WATER PERMIT NO. 6639-3

CENTERVILLE DAM DAM RECONSTRUCTION

TO: Jeff Peters, PE, Division of Administration, SD Game Fish & Parks
FROM: Len Neugebauer, PE/LS *Len Neugebauer*
DATE: September 15, 2005
RE: Hydraulic Review and Comments on Preliminary Plans (DGR#648181, Centerville Dam)

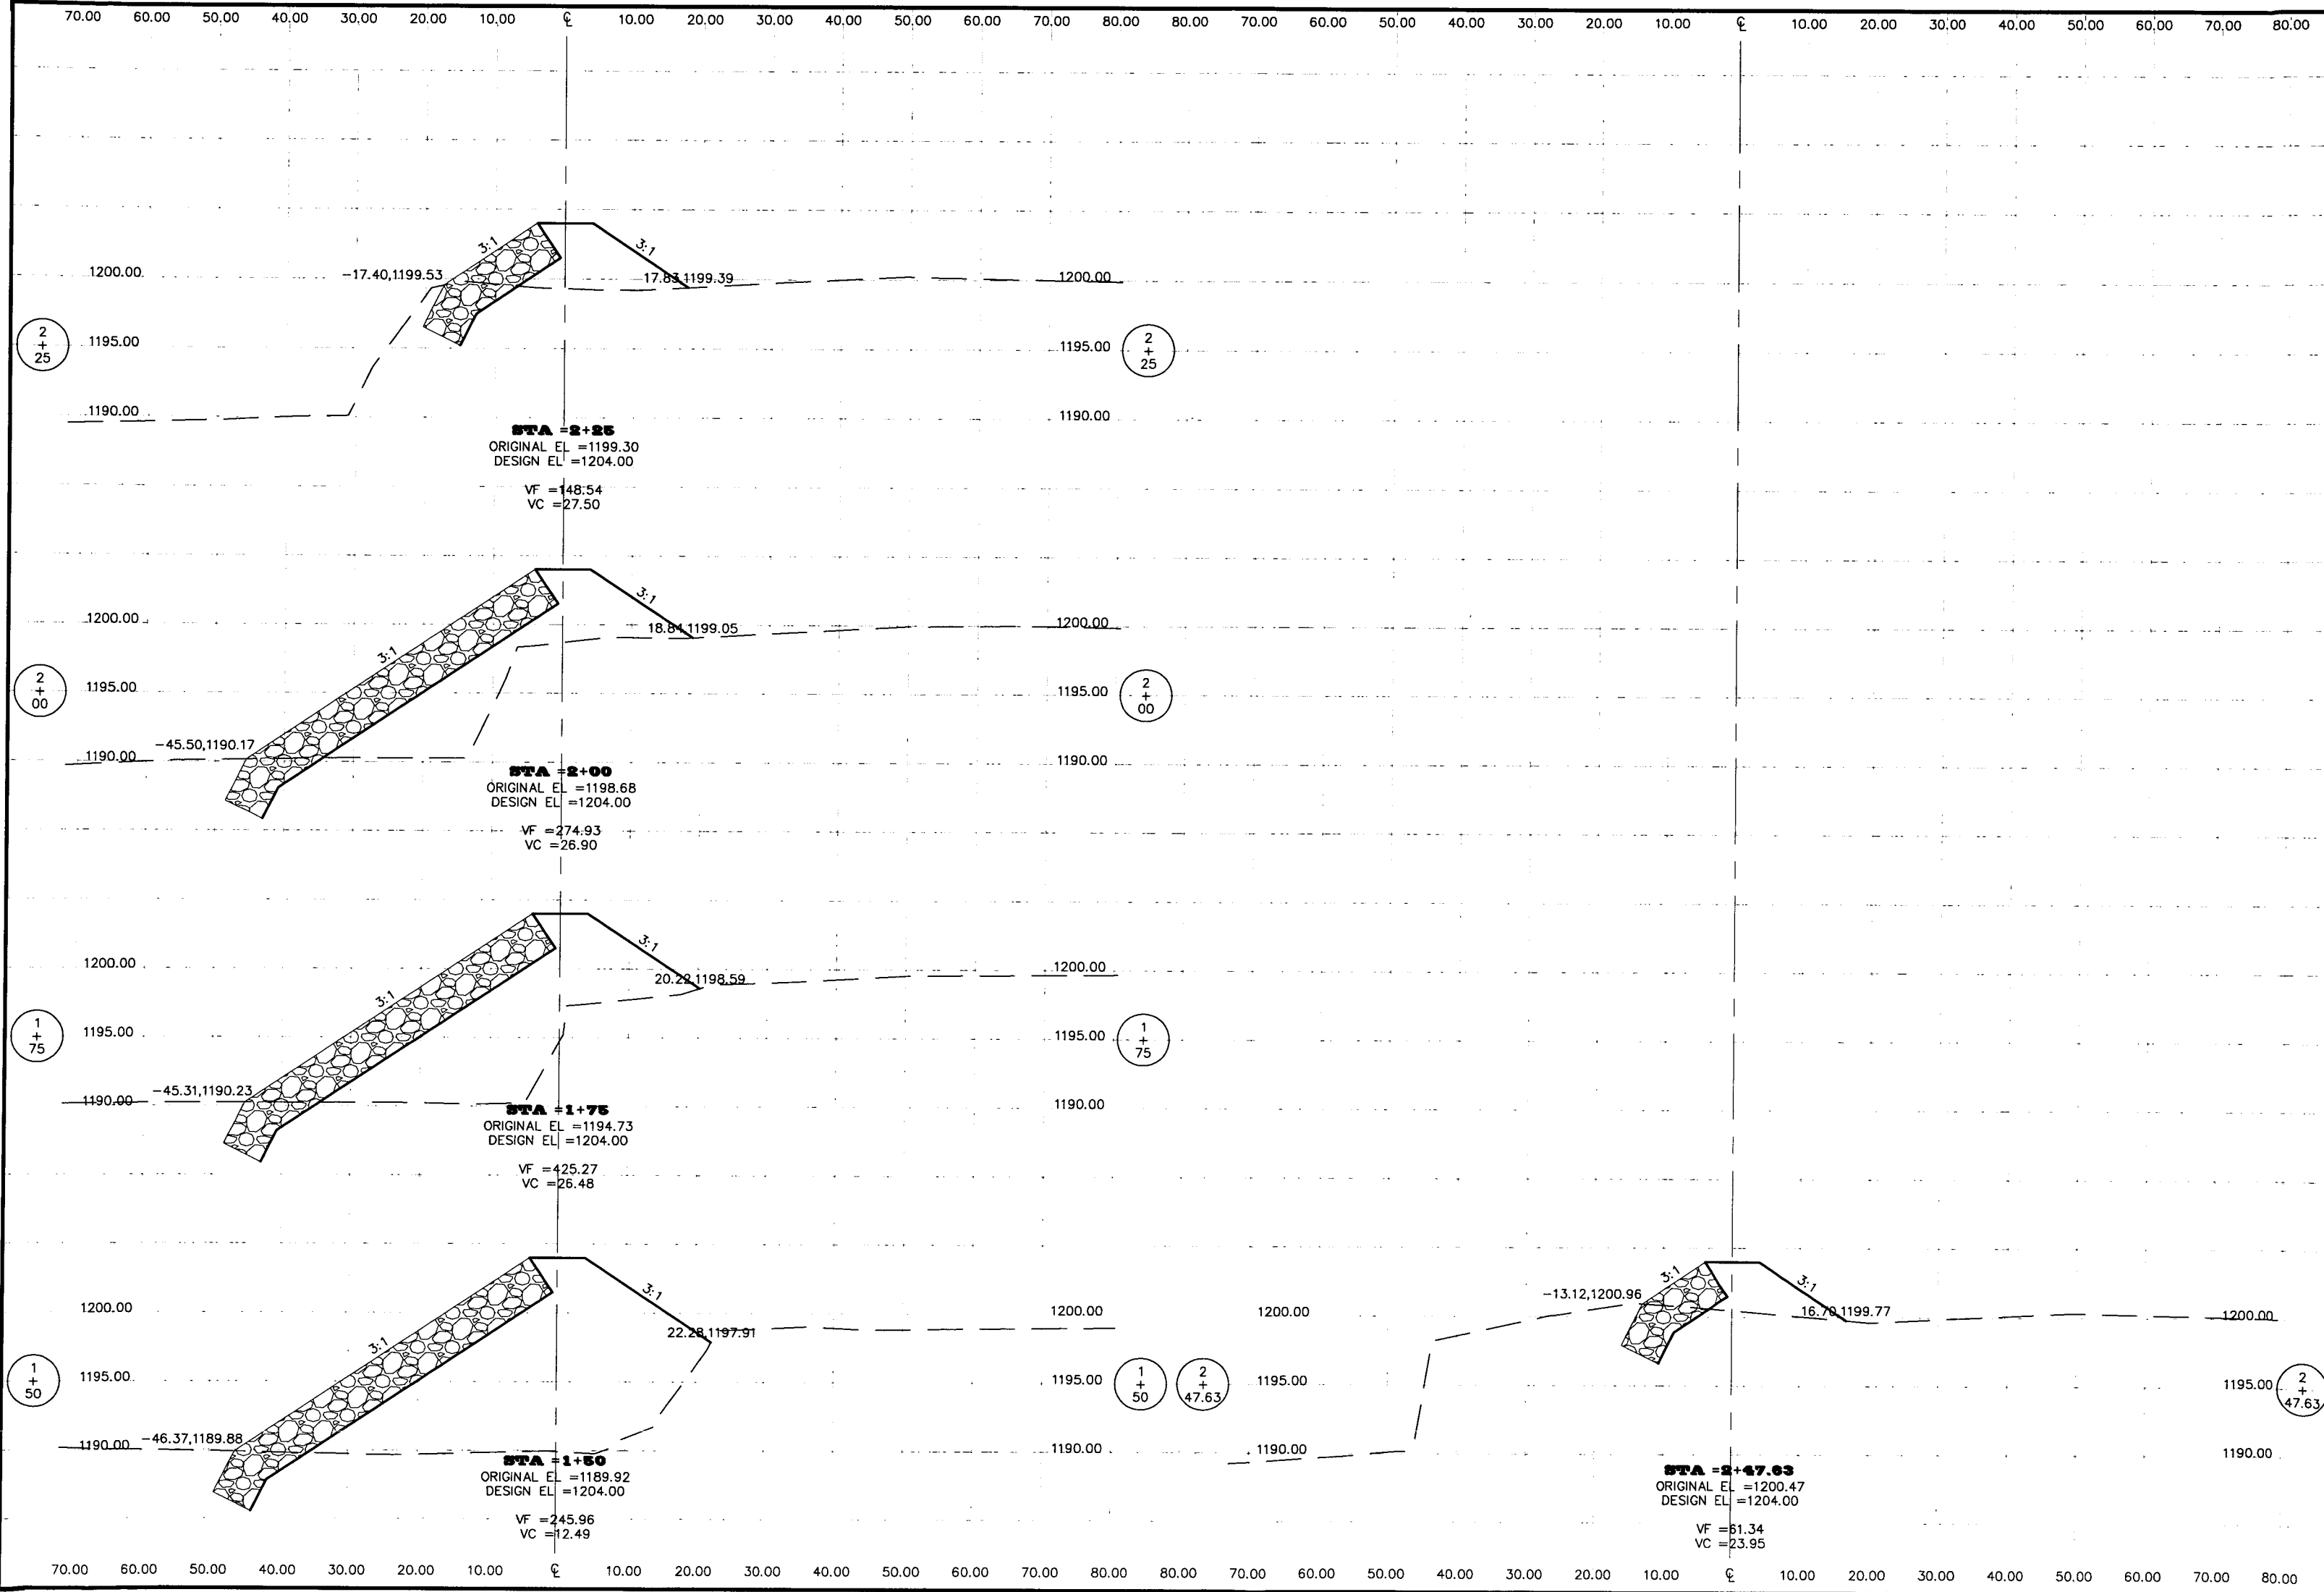
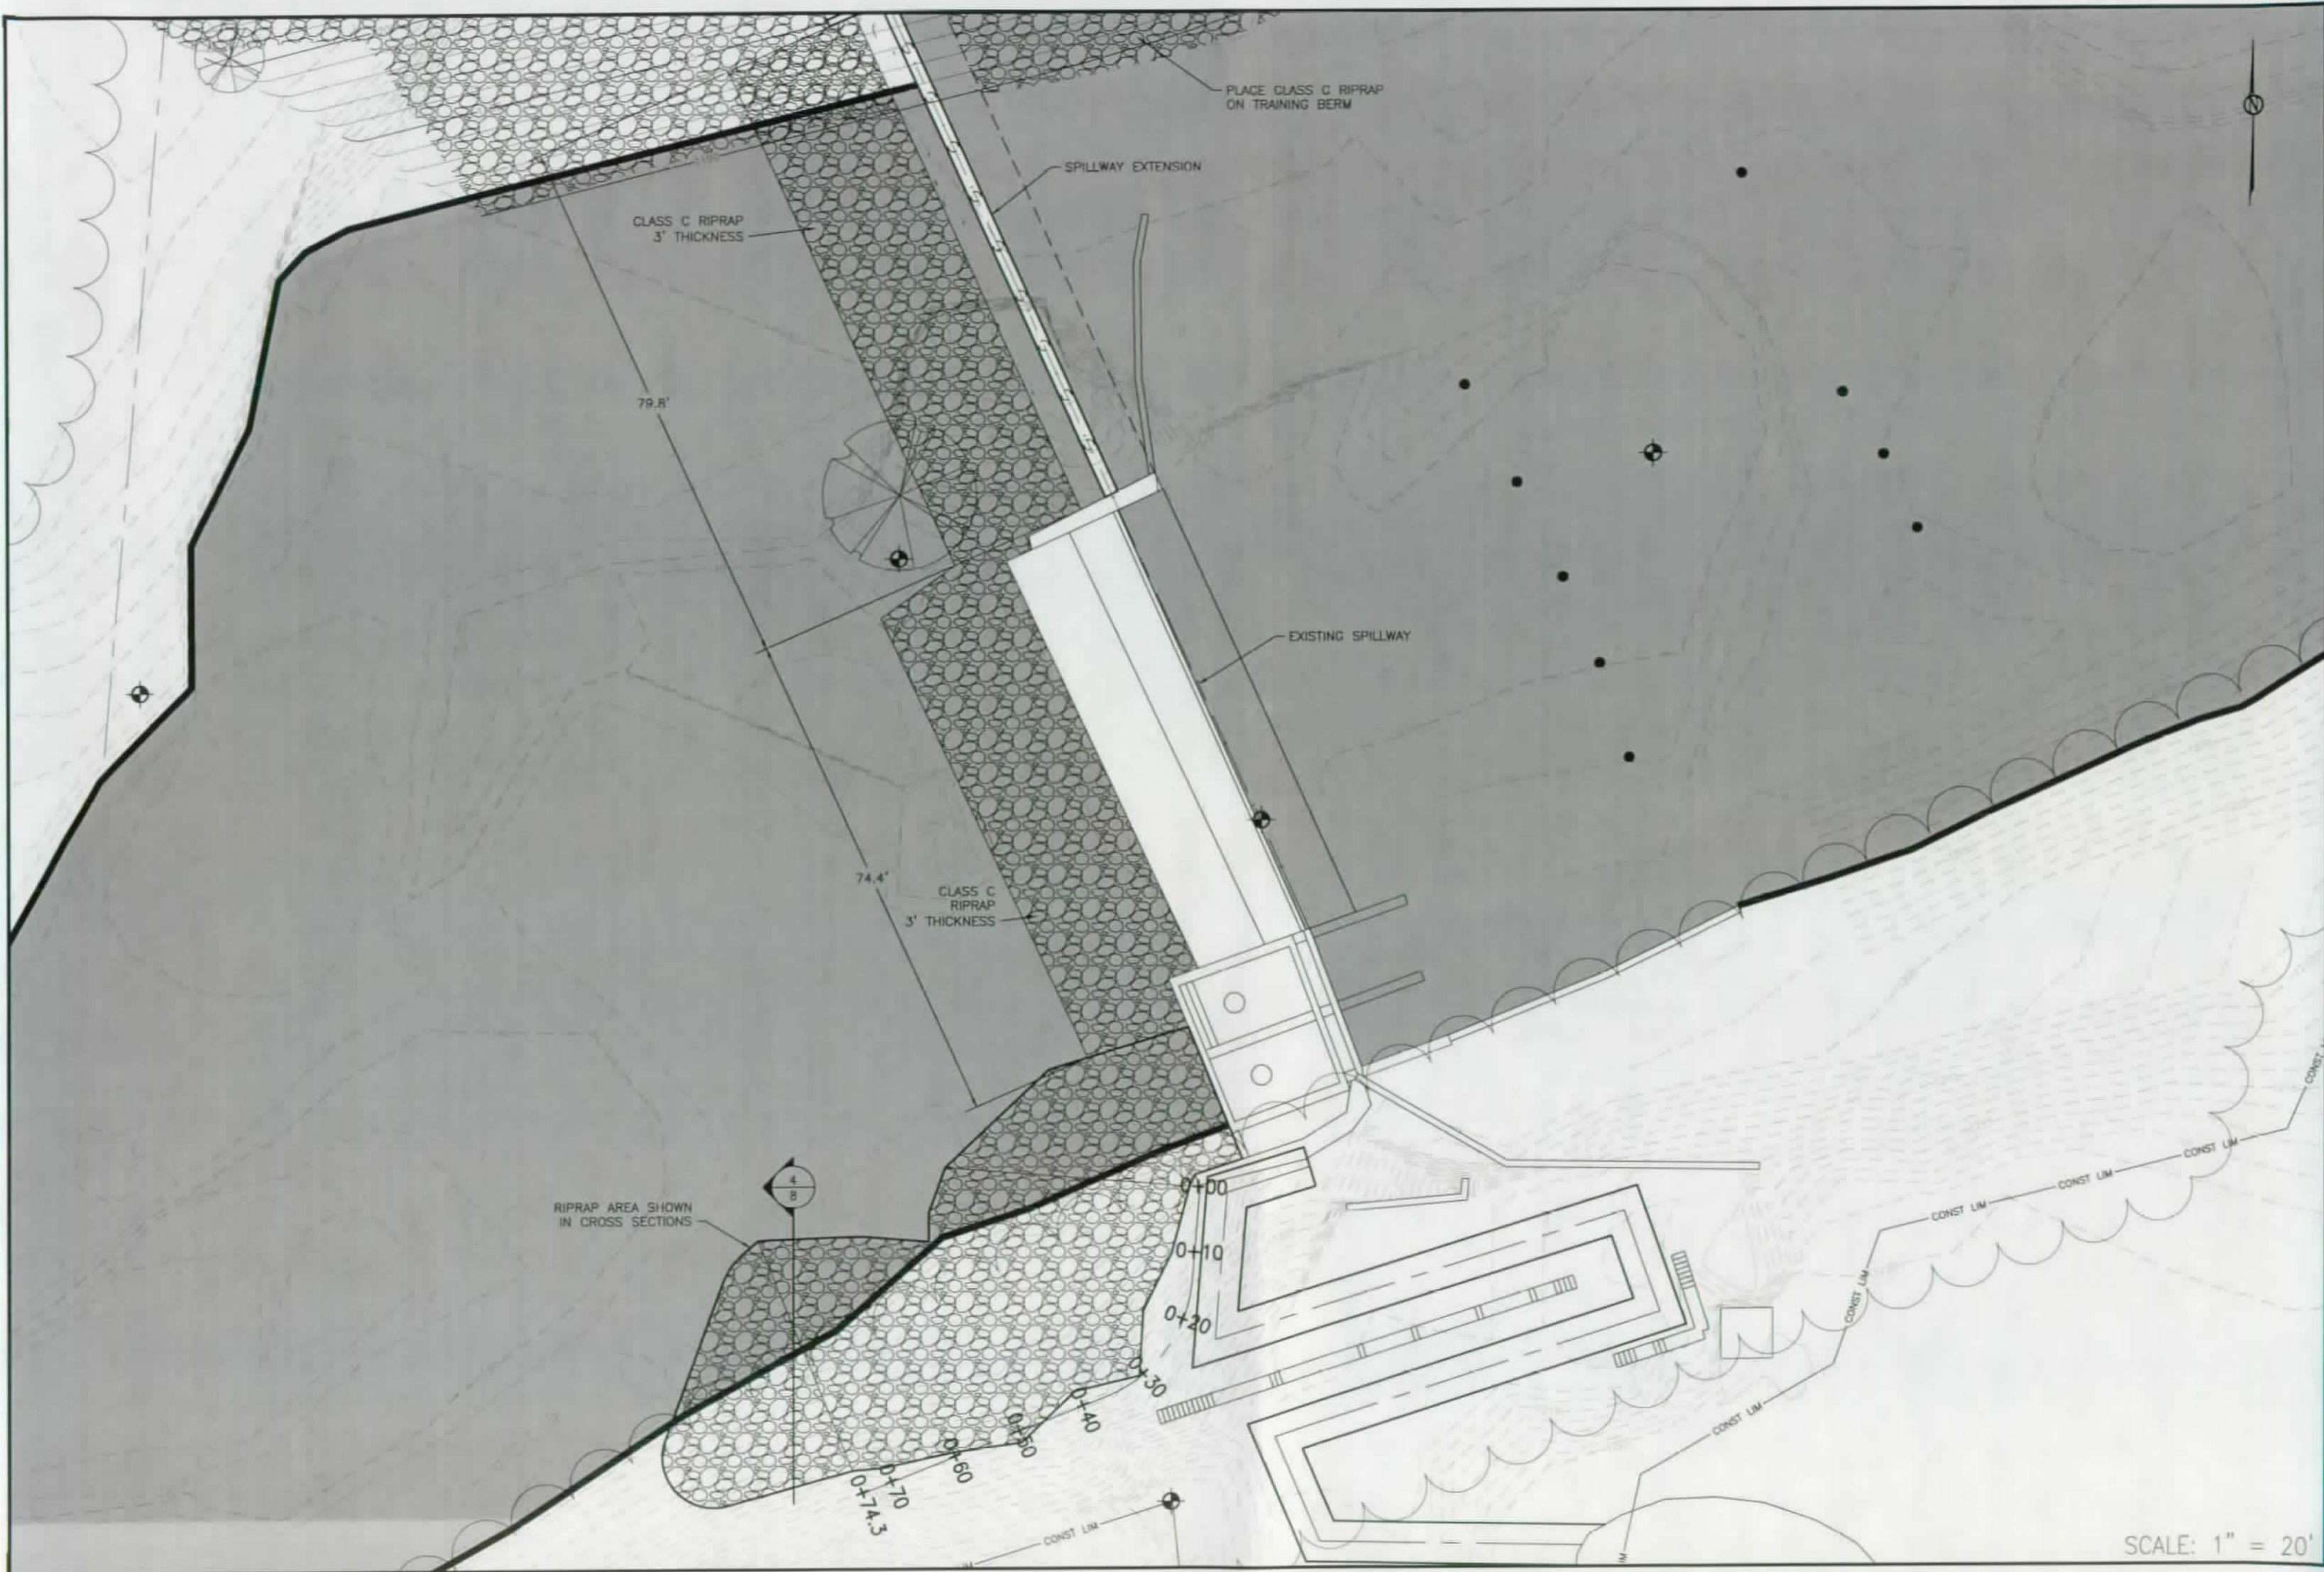
1. Sheet 24 of 47: I would recommend that the top of wall and top of berm at the north end of the spillway extension be at elevation 1207 (3' higher than you show it). I would recommend a clay cut-off core trench and extending your anti-seep wall as shown.
